Re: Review of the Drayton South Coal Project 'Preferred Project Report'

We reviewed the Drayton South Coal Project Environmental Assessment (EA) in January 2013 for Coolmore Australia (Coolmore) and Darley Stud (Darley). You have now commissioned Gilbert & Sutherland to review the Drayton South Coal Project Response to Submissions Report ('the Response Report', prepared by Hanson Bailey in May 2013) and a Preferred Project Report ('the PPR', prepared by same in August 2013). Our aim was to assess whether the issues highlighted in our review of the EA had been addressed in the Response Report and/or rectified in the updated proposal for development of the Drayton South Coal Project. A copy of our January 2013 review is attached to this document as Attachment 2.

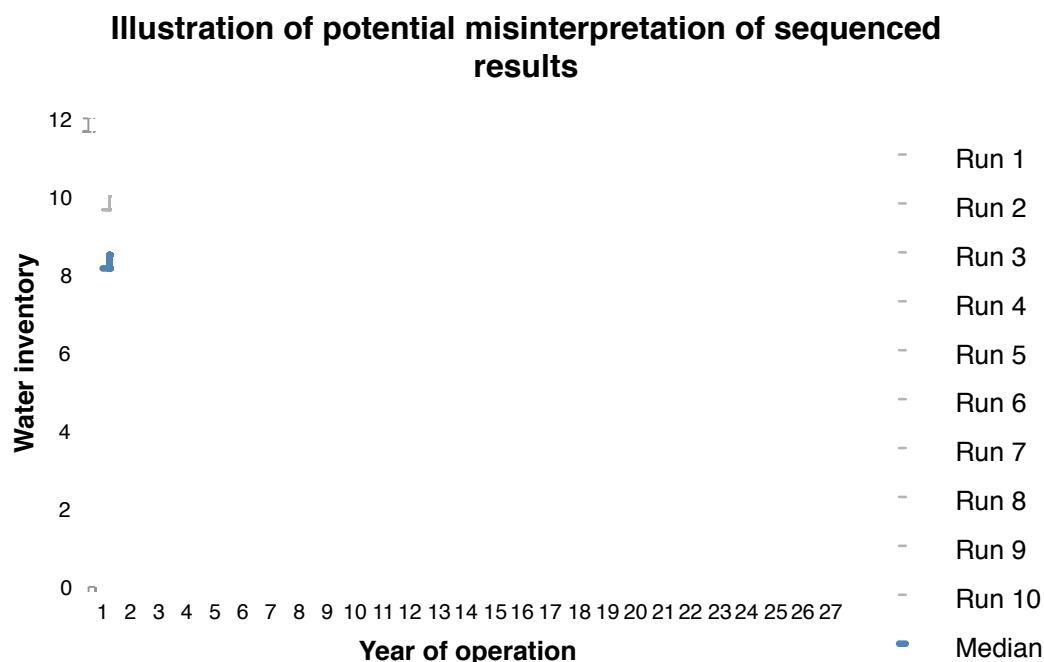
The validity of any numerical assessment of potential impacts on the quantity and quality of surface water is wholly dependent on the ability of the models employed to accurately represent variable conditions. The long-term behaviour of the quality and volume of mine waters requiring management, the impacts of mine operations and the fate of contaminants all rely on the veracity of the estimates proffered.

In this case, the reported water balance modelling fails to provide a justifiable basis for the conclusions drawn in the report. The probabilistic values reported are not statistically valid and the forms of analyses are potentially misleading. They do not support the interpretation of the results provided.

The underlying assumptions of the water balance modelling regarding the behaviour of the mine waters, particularly with respect to the EA's volumetric treatment over the life of the proposal, require further justification. For example, the statistical description of water balance results to a 1% level of reporting cannot be justified. The modelling employed a data set (drawing from 114 years of data from 1893 to 2006) but provided only 88 sequences. Both the use of these data and the partial selection of sequences are inadequate to support the quoted probabilities of 1%.
